QUESTIONS & ANSWERS #1

TRAFFIC SIGNAL UPDATE PROJECT CIP NO. 17058 HSIPL 5242 (034)

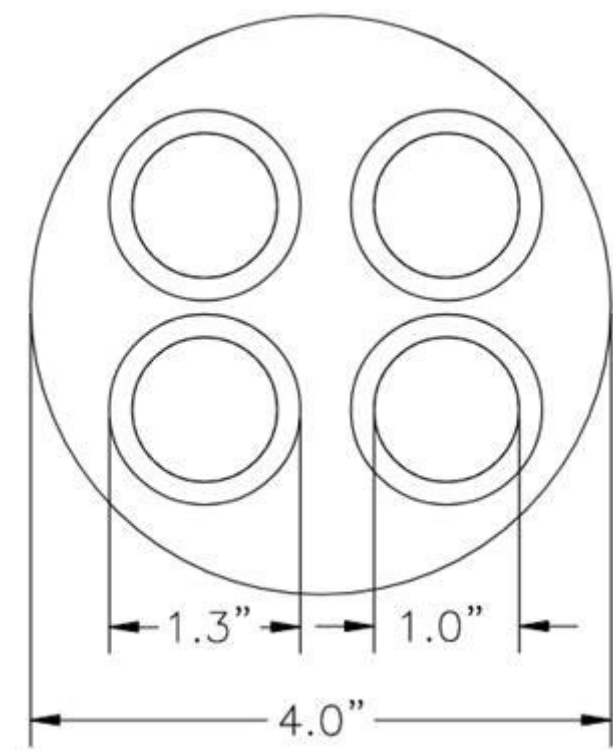
Q.1.2. Plan Sheet SIC-5 – Contractor is directed to install (4) 1” SDR 11 into (1) 4” SDR 9 or 11. When referencing conduit a 1” – we are discussing the inner diameter of the pipe, this does not take into consideration the conduit wall thickness. The average outer diameter of a 1” SDR 11 is 1.315. Therefore, the sleeve must be upgrade to at least a 6” (**Size 5 ½” is not manufactured in SDR 9 or 11**) to accommodate (4) 1” SDR 11. (see below chart of pipe for reference)

A.1.2.
 For an innerduct with an outside diameter OD of 1.315” the area is 1.36 square inch, or 5.44 square inch for all 4 innerducts.
 The area for a 4” conduit with an inner diameter of 3.633” is 10.37 square inch.
 Therefore, this should leave plenty of room for the 4-1” innerducts to be inside a 4” Conduit.
 Please also see image below for a scaled drawing of the innerducts as listed above.
